South Texas Project Electric Generating Station 4000 Avenue F - Suite A Bay City, Texas 77414

June 12, 2008
ABR-AE-08000043

South Texas Project
Units 3 and 4
Docket Nos. 52-012 and 52-013
Response to Requests for Additional Information

Attached are responses to NRC questions included in Request for Additional Information letter numbers 7, 10, 23, 25, 26, 27, 28, 29, 30, 31, 32, and 42 related to COLA Part 2, Tier 2, Sections 2.3, 2.4, 3.6, 9.1, 9.3, and 10.4. This submittal includes responses to the following Question numbers:

Figure 1
STP Stability Class Frequency Distributions

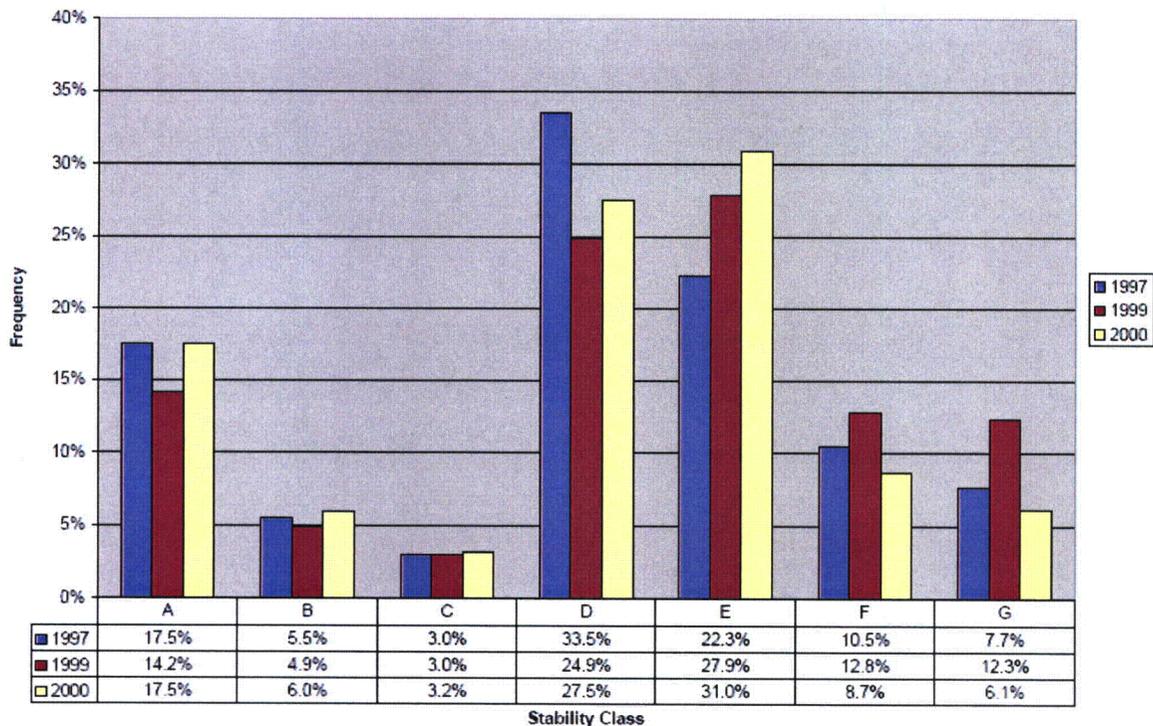
Please explain the variation in onsite G stability class frequency distribution from year to year (e.g., 12.3% in 1999 versus 6.1% in 2000) as shown in Figure 1.

The G stability Class frequency differences are attributed to year-to-year variation and are within the norm of the yearly variation. Examination of seven years of STP onsite historical stability class frequency distribution data show several year-to-year variations of greater than 6.2% (the G stability Class frequency difference between 1999 and 2000), for stabilities other than G.

Distance from Units 3 & 4 to EAB

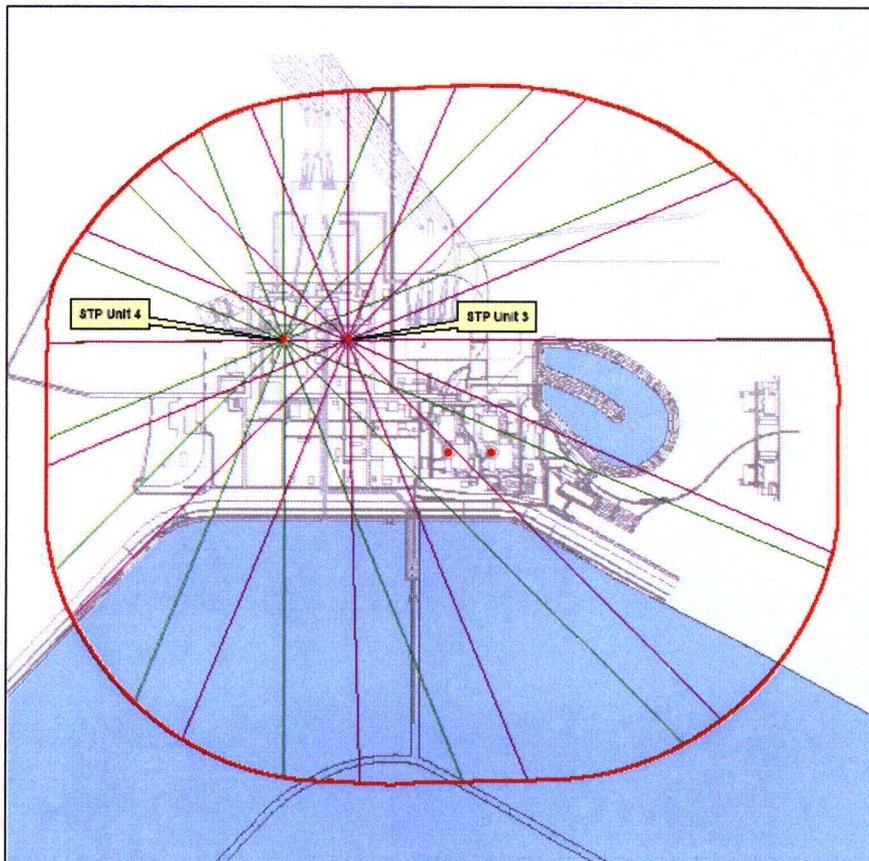
Section C.1.2 of Regulatory Guide 1.145 states that for each of the 16 direction sectors, the distances to the EAB and LPZ to be used in the χ/Q calculations should be the minimum distance from the stack or, in the case of releases through vents or building penetrations, the nearest point on the building to the EAB or LPZ within a 45 degree sector centered on the compass direction of interest. Please confirm that this was the approach used in deriving the distances to the EAB and LPZ presented in FSAR Table 2.3S-21 and 2.3S-22, or justify an alternative approach.

The distances provided in FSAR Tables 2.3S-21 and 2.3S-22 were the exact distances obtained through the use of a Geographic Information System (GIS) analysis. The shortest distance to the Exclusion Area Boundary (EAB) was in the NW direction. In this direction, the distance provided in Table 2.3S-21 is the shortest distance from the center of Unit 4 to the direction of interest (NW). Therefore, the release was assumed to be located at the center of either Unit 3 or 4, not the nearest point on the building to the EAB or Low Population Zone (LPZ).

As shown on the attached figure, our alternative approach uses the distance from the center of Unit 4 in the NW direction. The shortest distance from the center of Unit 4 to any point in the 45-degree sector is similar. It is acknowledged that in the NW direction, the difference in distance from the edge of the reactor building to the EAB is about 135 feet (41 meters) shorter than if measured from the center of Unit 4. A 4.4% (41 m/930 m) difference in this distance does not significantly affect the χ/Q value predicted at the EAB.

The following discussion provides the basis for this selection. When varied direction-specific boundary distances are entered into the PAVAN code, the model cannot generate the overall 5% χ/Q values. This is a limitation of the PAVAN code. In order to obtain the maximum overall 5% χ/Q value, PAVAN was run separately for each direction-specific boundary distance for each of the 16 different directions. The ultimate maximum 0-2 hour χ/Q value was selected from the 16 sets of data using the lowest or most conservative distance (930 m). As reported in FSAR Tables 2.3S-23 and 2.3S-24, the maximum overall 0-2 hour 5% χ/Q at the EAB and LPZ, respectively, was selected by the above alternative approach.

Specifically, the 0-2 hour maximum overall 5% χ/Q at the EAB (1.96E-04) was obtained from a PAVAN run using a constant downwind distance of 930 meters for all directions. In reality, aside from only this one sector (NW direction), the downwind distances to the EAB are all greater for the rest of the directions. This approach is conservative because it assumes all downwind distances are 930 meters to the EAB.

In conclusion, the net result of the conservative approach used in the final selection of the 0-2 hour maximum χ/Q values out-weighs the use of the distance measured from the center of Unit 4, rather than from the nearest point on the building.

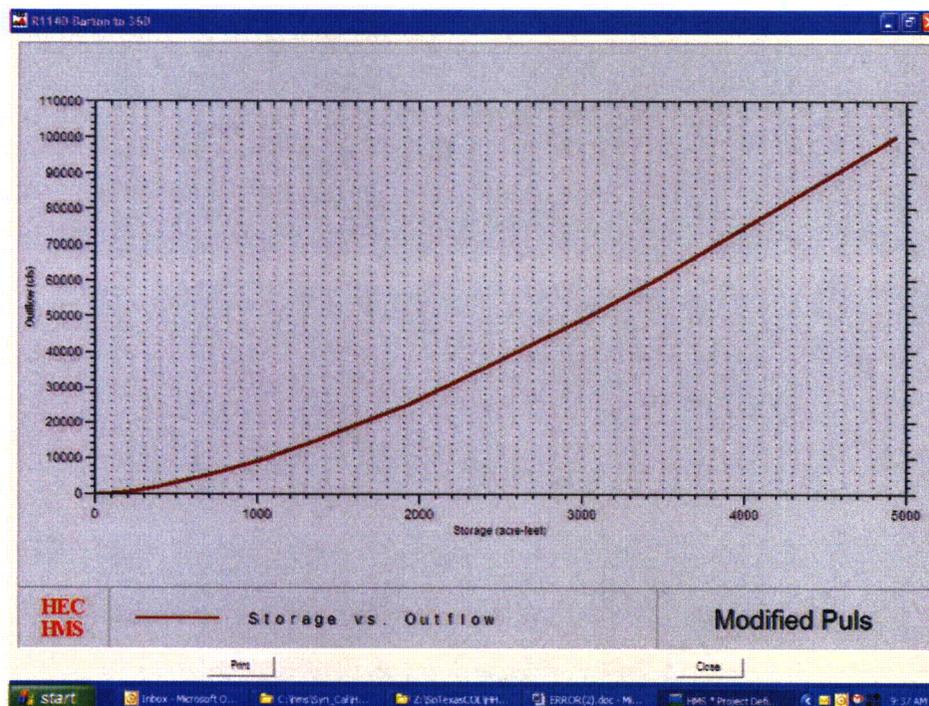
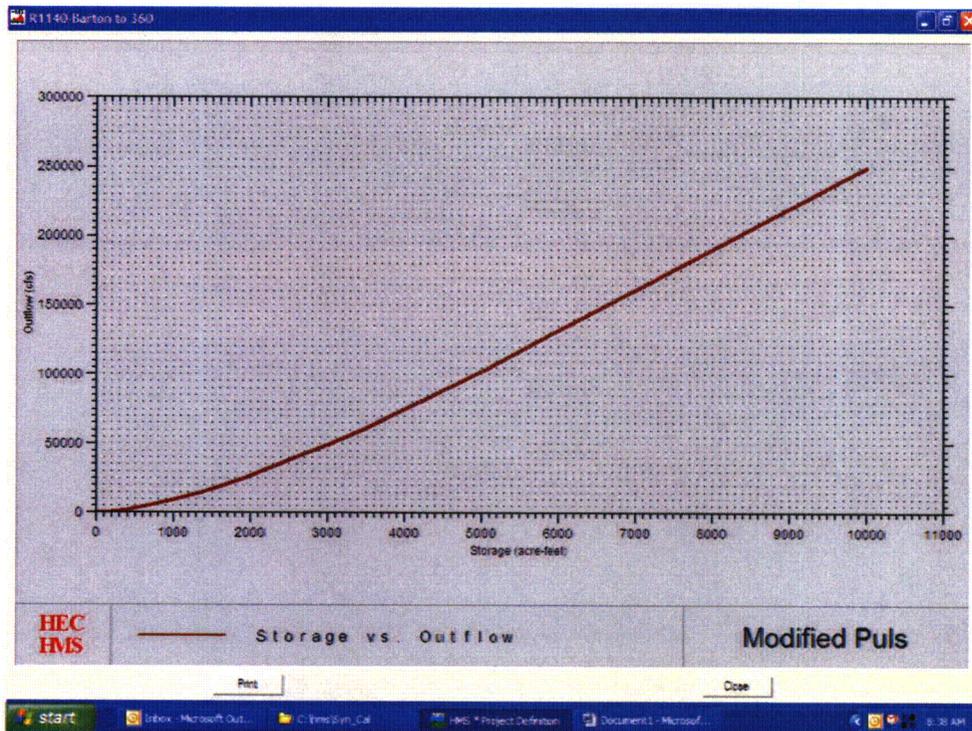
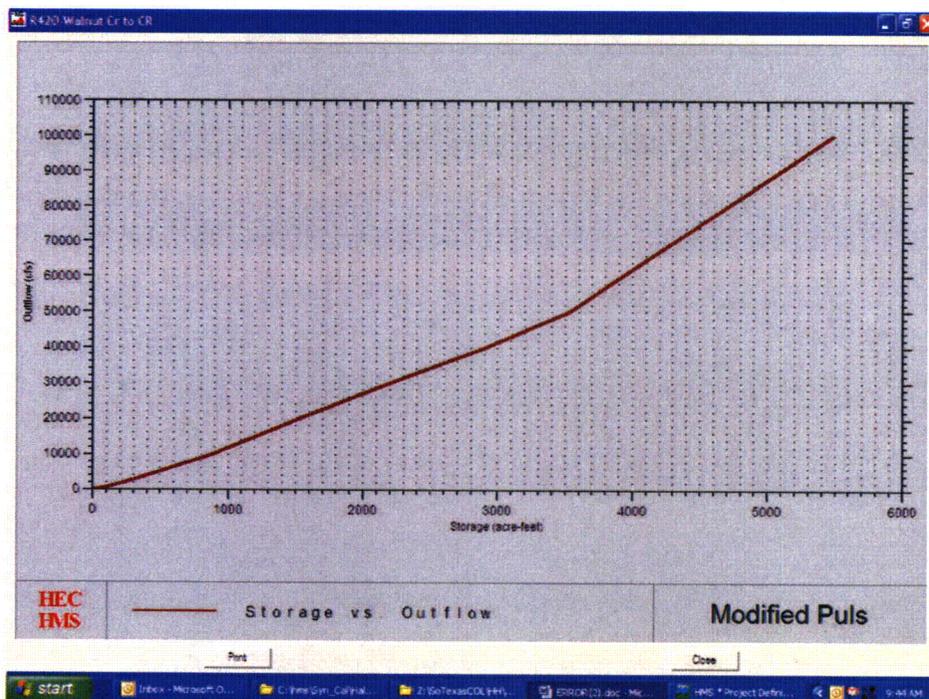
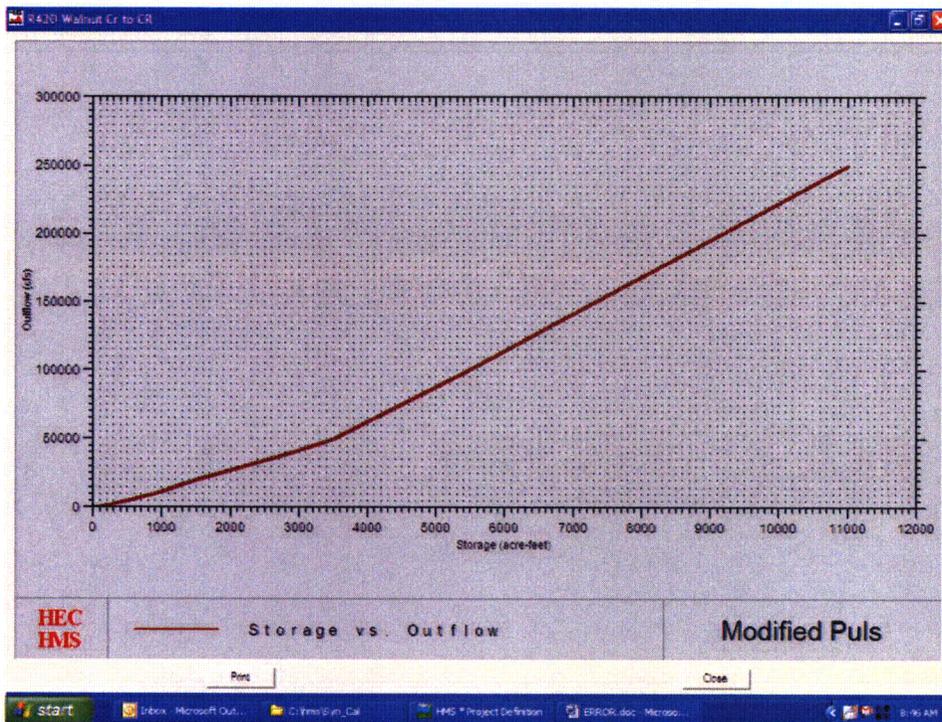
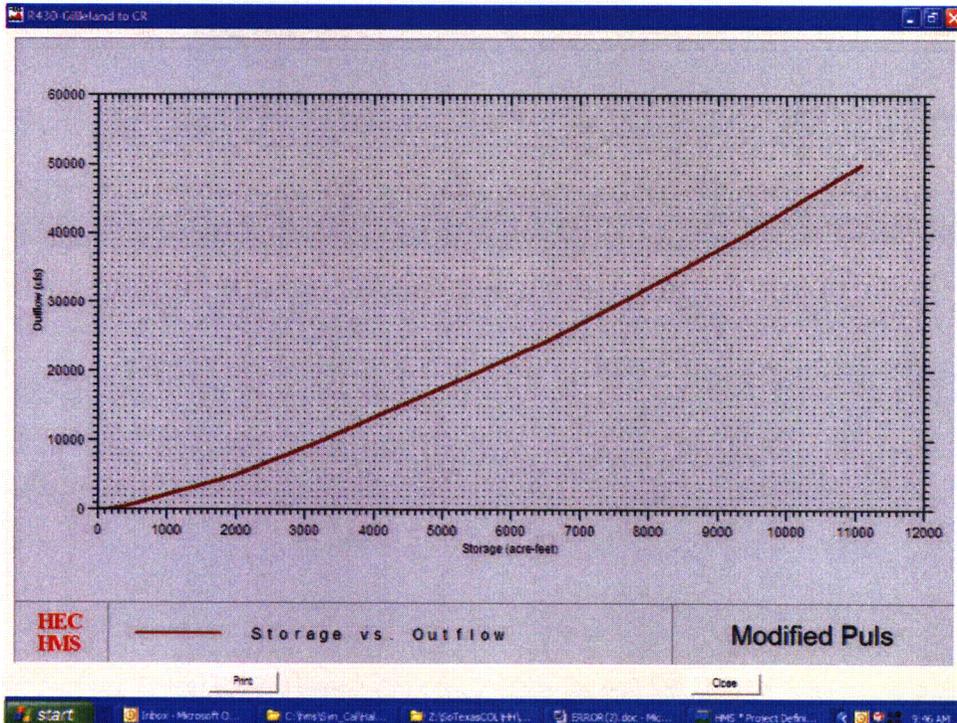
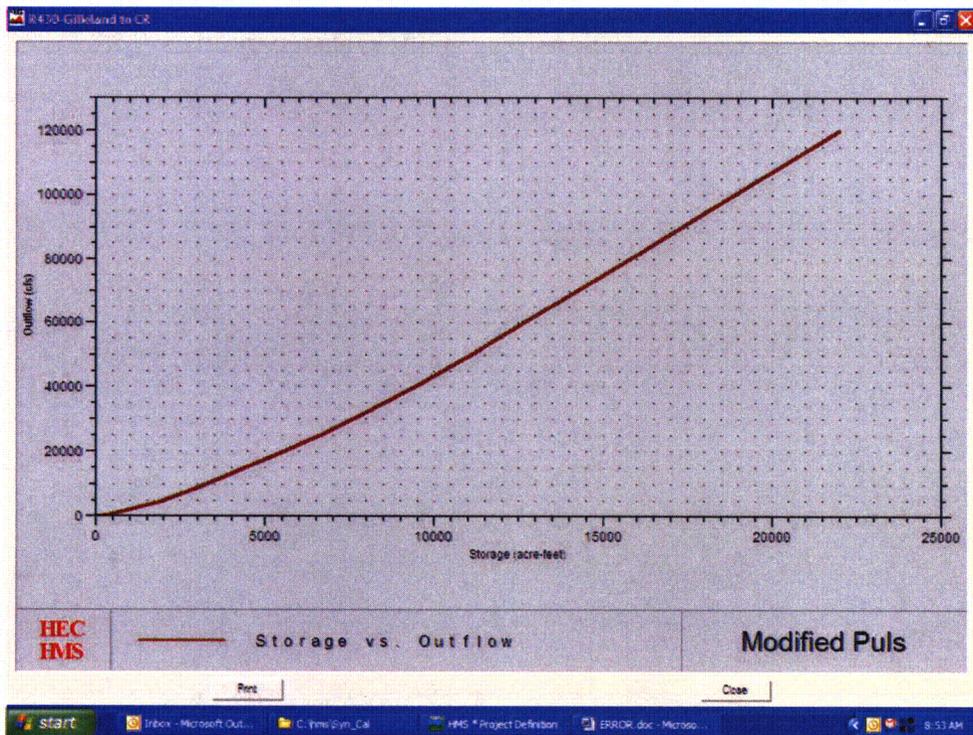
Provide details of the linear extrapolation used to extend the channel rating curves between Mansfield Dam and Matagorda Bay described in FSAR Section 2.4S.3.3.

A linear extrapolation was used to extend three channel rating curves: R1140-Barton, R420-Walnut Cr, and R430-Gilleland. The following figures provide the original rating curves used in the Half HEC-HMS Model and the extrapolated rating curves used for the Probable Maximum Flood (PMF) Analysis in FSAR Section 2.4S.3.

FIGURE 9.3-11 PIPING AND INSTRUMENTATION DIAGRAM, RADIOACTIVE DRAIN TRANSFER (SHEET 1 OF 22)

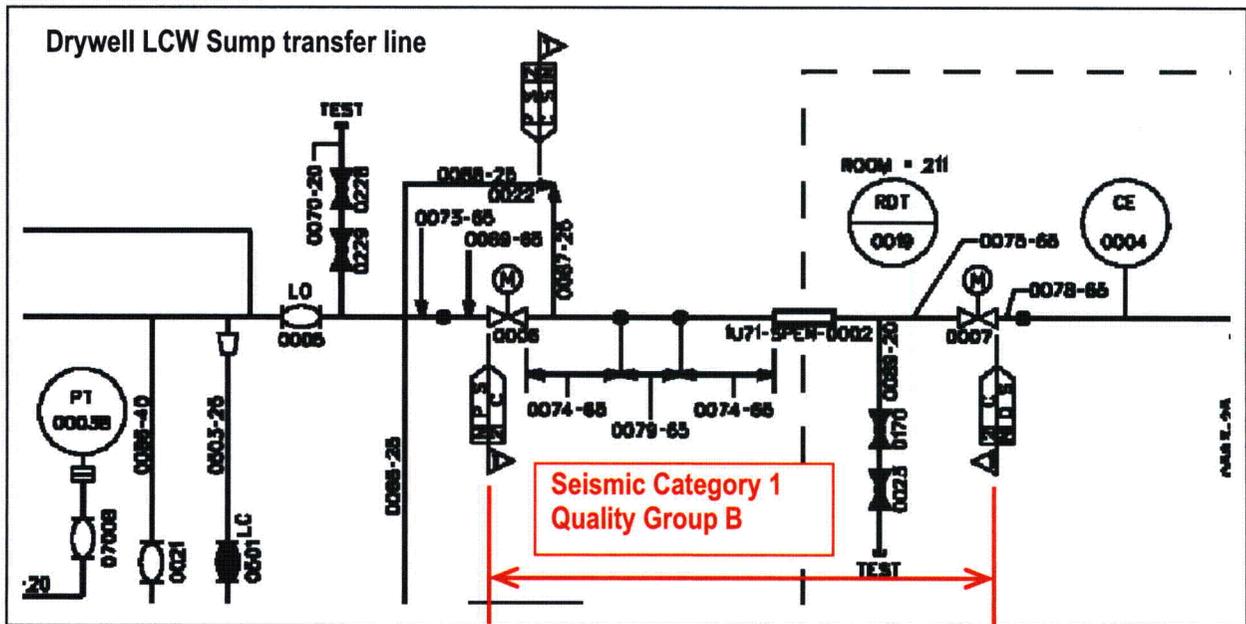
Please clarify if MOV 006 and MOV 007 in Sheet 1 of COLA FSAR Revision 1, Figure 9.3 11, are containment isolation valves.

The valves numbered as MOV 0006 and MOV 0007 in Sheet 1 of Figure 9.3.11 are containment isolation valves. Sheet 5 of Figure 9.3.11 in the current FSAR revision incorrectly shows the containment isolation valves, which are numbered 0057 and 0065, as ball valves. Sheet 5 will be corrected to show both as motor operated isolation valves as attached.

FIGURE 9.3-11 PIPING AND INSTRUMENTATION DIAGRAM, RADIOACTIVE DRAIN TRANSFER (SHEET 6 OF 22)

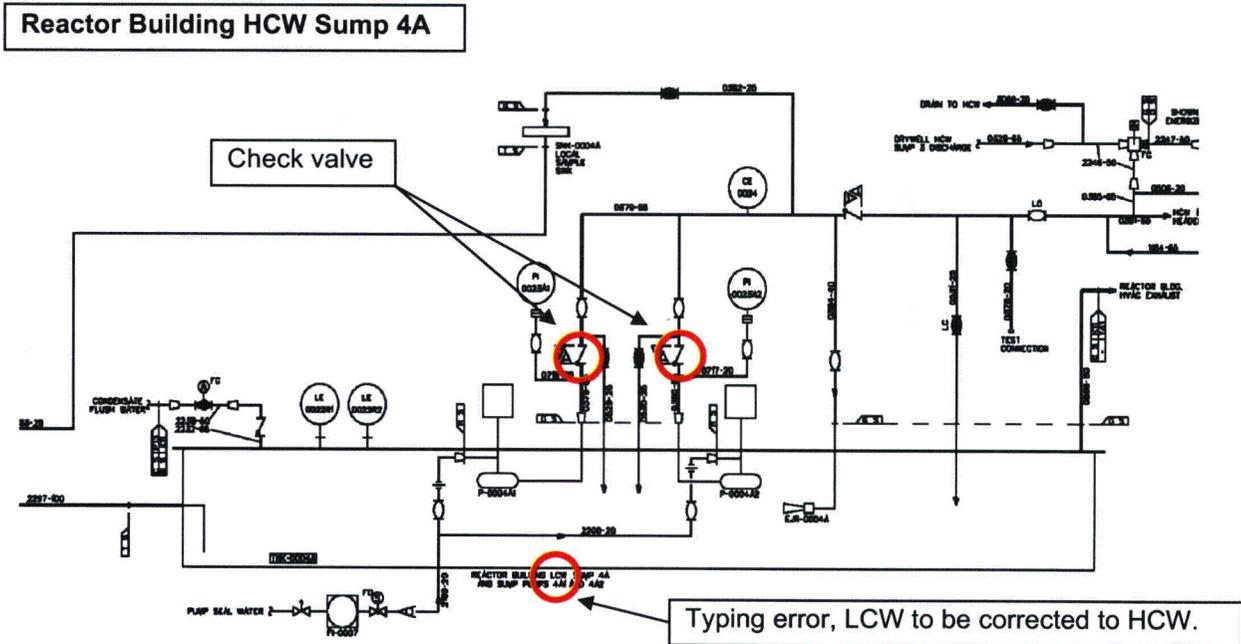
ABWR DCD Section 9.3.8.1.1, "Safety Design Bases" Item 5(a) states that backflow check valves should be included in the ECCS equipment room sumps. Item 5(b) states that floor drain piping in each divisional area of the ECCS pump rooms and the Control Building shall be arranged so that flooding or backflow in one quadrant will not adversely affect other quadrants. The staff could not locate in the P&IDs the check valves and sumps for each ECCS equipment room. Please include these components (or add a reference to) in COLA FSAR Figure 9.3-11.

The drains from the ECCS equipment rooms A, B and C are collected in the individual HCW sumps located in each room. The sumps are HCW Sump 4A on Sheet 6 of Figure 9.3-11, and 4B and 4C on Sheet 7 of Figure 9.3-11. The sump pump is actuated on a water level high signal to prevent flooding. The suction line of each of the relevant sump pumps has a check valve to prevent backflow. The check valve is located in the HCW sump in the individual ECCS equipment room.

Please note that the name of the sump in Sheet 6 is Reactor Building "HCW" SUMP 4A not "LCW" SUMP.
